# PXD Electronics

- **Belle II PXD ASICs review II**

*Belle II PXD Report: DCD and Switchers, August 2015*

## DCD and Switchers Design Review Report

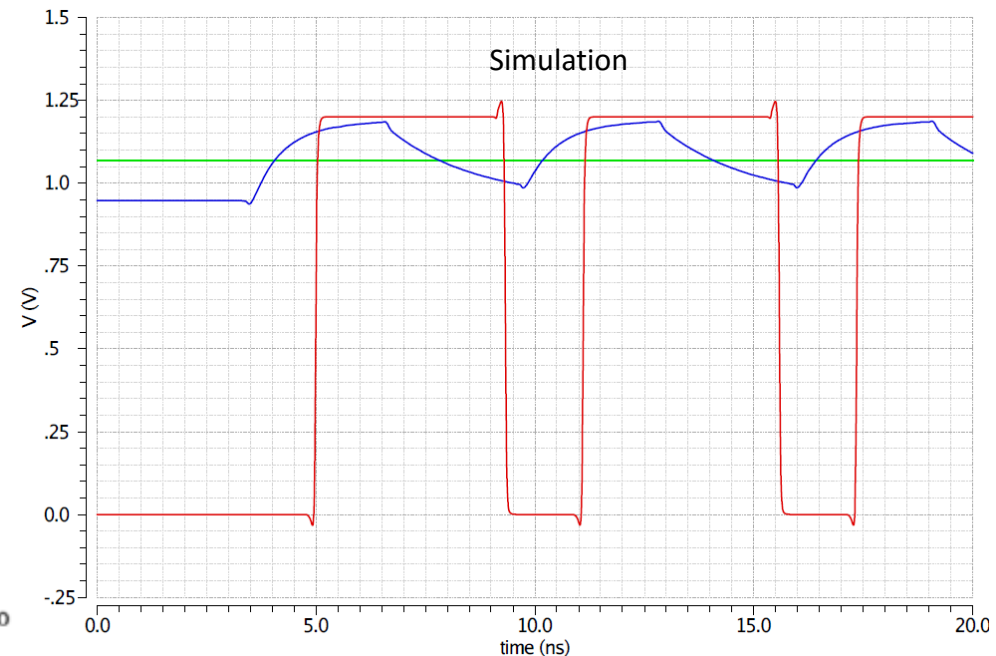
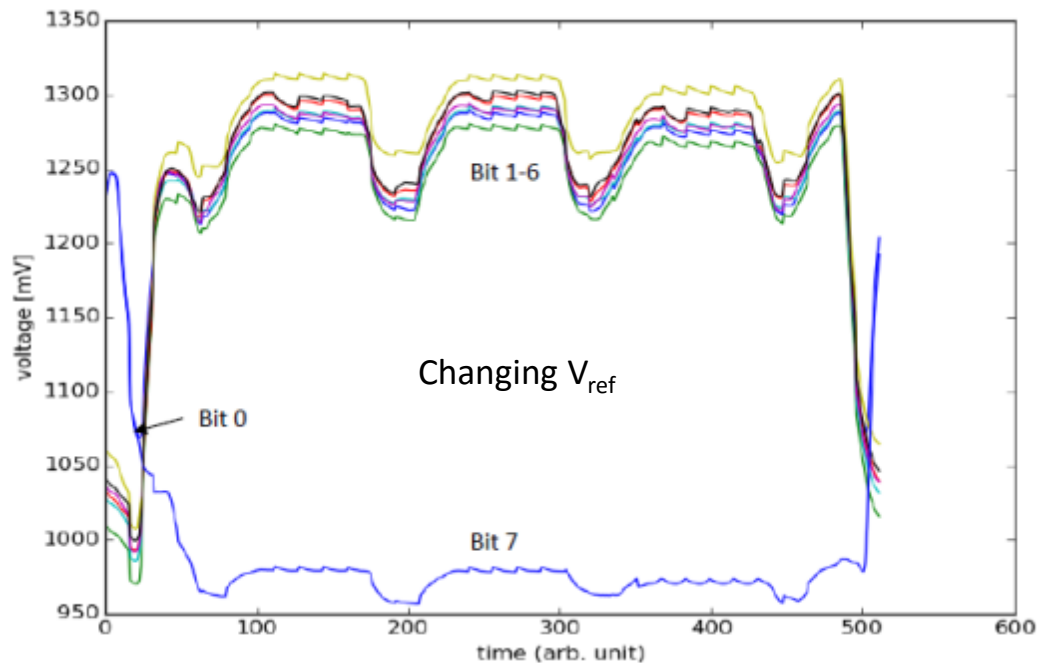
- 5 boards with DCDBPipeline assembled
- Main investigations on DCD-DHP data transmission
- 64 data links tested using DCD test pattern
- Main issue revealed: Critically small sampling window!

Ideal logic zero sampling window : **3.125 ns**  
Measured logic zero sampling window = **1 ns**

- Digital transmission DCD-DHP:
  - Reduce parasitic capacitance of DHP input pads
  - Remove hysteresis on the receiver side
  - Increase the DCD output strength
- Missing codes:
  - Minimized by optimized DAC and bias settings
  - Not relevant for the experiment
- Internal gain and pedestal correction:
  - Adapt based on recent PXD9 static measurements
- Change sampling polarity according to standards:
  - Sampling data at JTAG TCK raising edge
  - Release data at falling edge

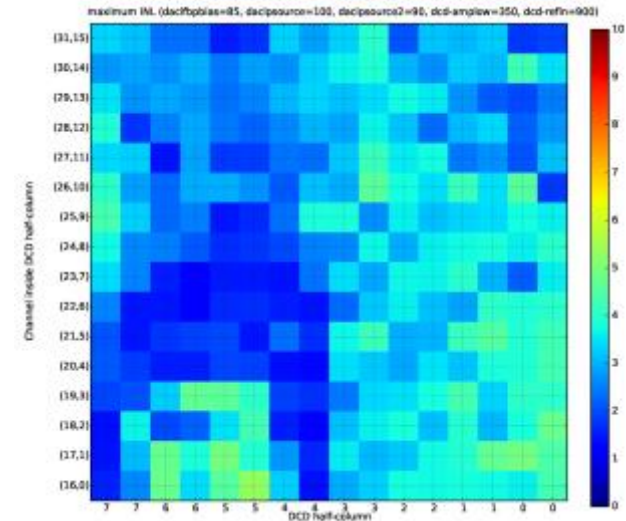
At 2 Mrad the delay tolerance shrinks, although we always found a region with no transmission errors

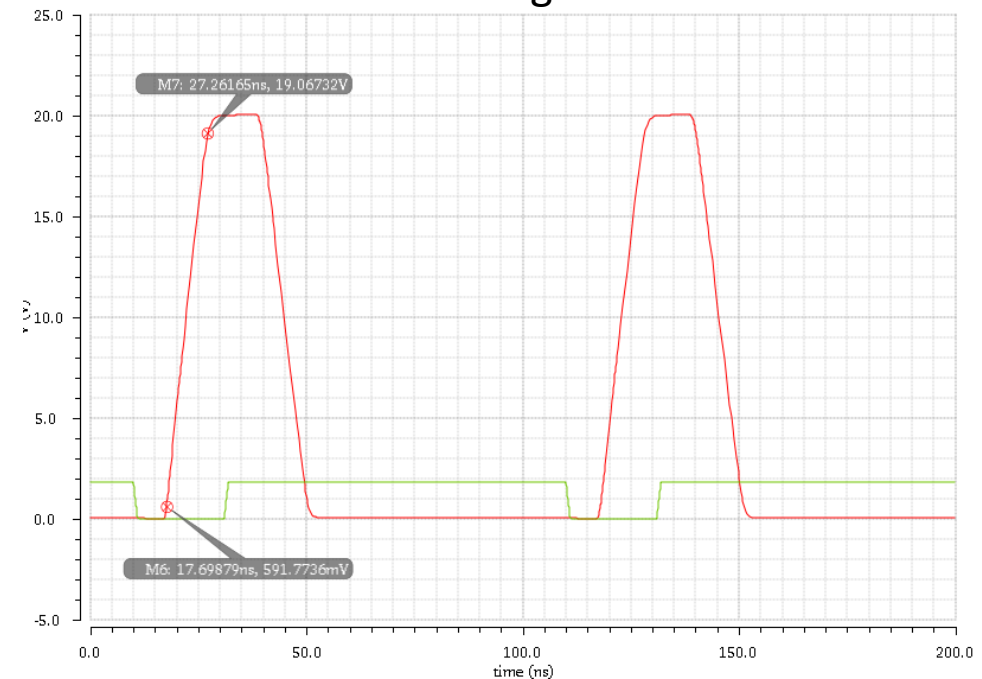
Rise time: 10 ns  
Capacitor = 150 pF  
ClearHigh = 20 V

- Faster rise time:
  - Larger switching transistors
  - Increase decoupling capacitors
- Termination resistors always on
- Bump pads:
  - Resize of pads on last metal layer
